TECHNICAL SERVICE BULLETIN

Various Concerns With The Active Exhaust System

22-2282

Ford 2018-2022 Mustang	non-Shelby GT350
----------------------------------	------------------

Figure 1 - Exhaust clamp locking tabs

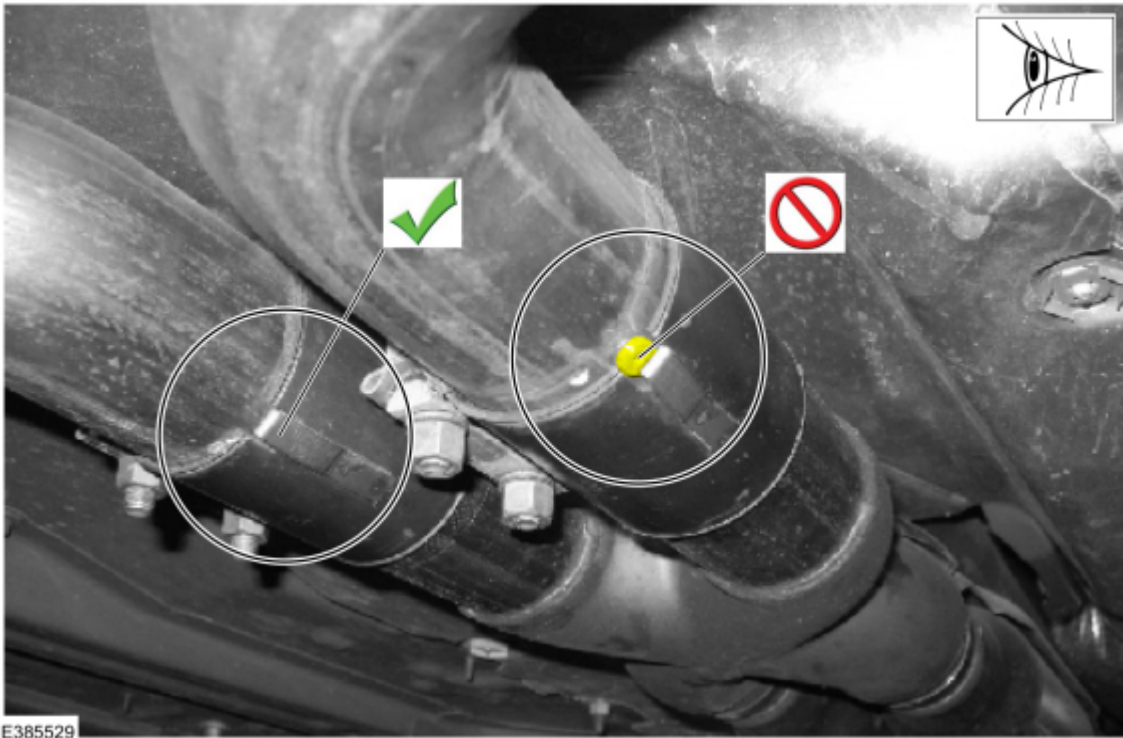
- Is the concern still present?
 - Yes - proceed to Step 5.
 - No - repair is complete.
- Inspect the muffler and tailpipe assembly and both catalytic converters for proper positioning in the exhaust clamps which secure them together. Make sure the exhaust clamp locking tab is fully engaged to the catalytic converters (Refer to Figure 1). Make sure the knurled/ridge area of the muffler and tailpipe assembly are covered by the exhaust clamps (Refer to Figures 2-3). Adjustments can be made by loosening the exhaust clamps and repositioning the muffler and tailpipe assembly. (Figures 1-3)

Figure 4 - GT500 shown, other vehicles similar

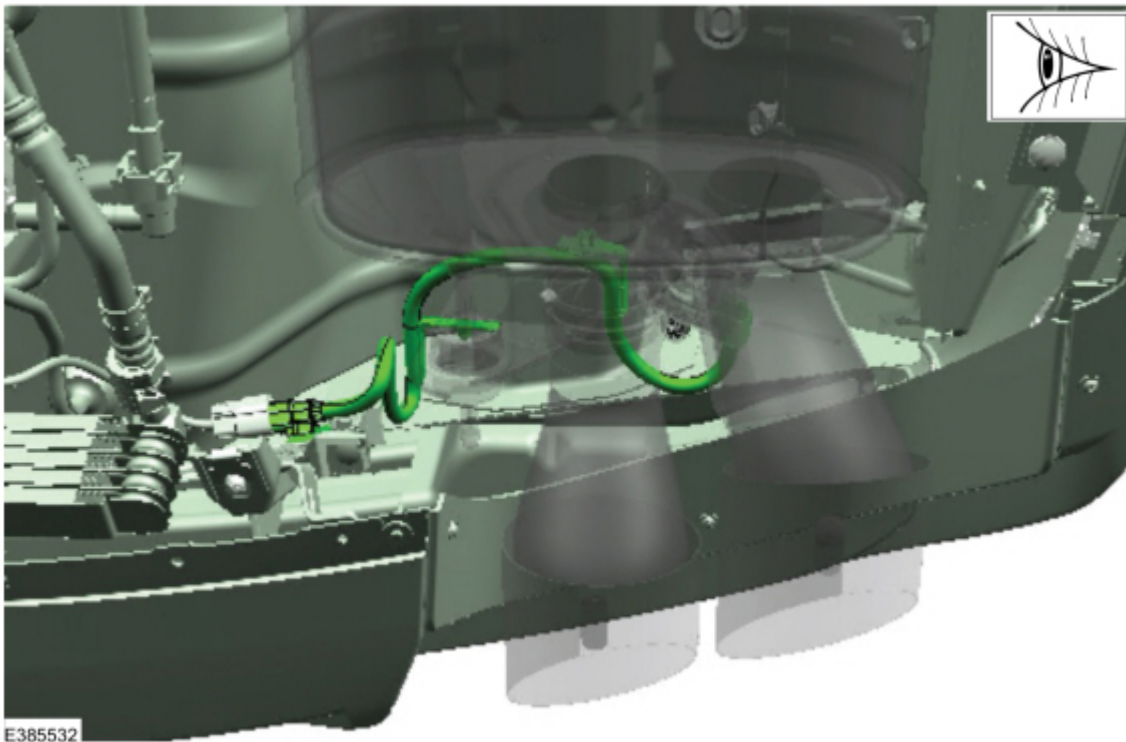
6. Inspect the exhaust actuator wiring harness for signs of damage. If damage is found, replace the exhaust actuator wiring harness (service base part number: 14A411). (Figure 4)
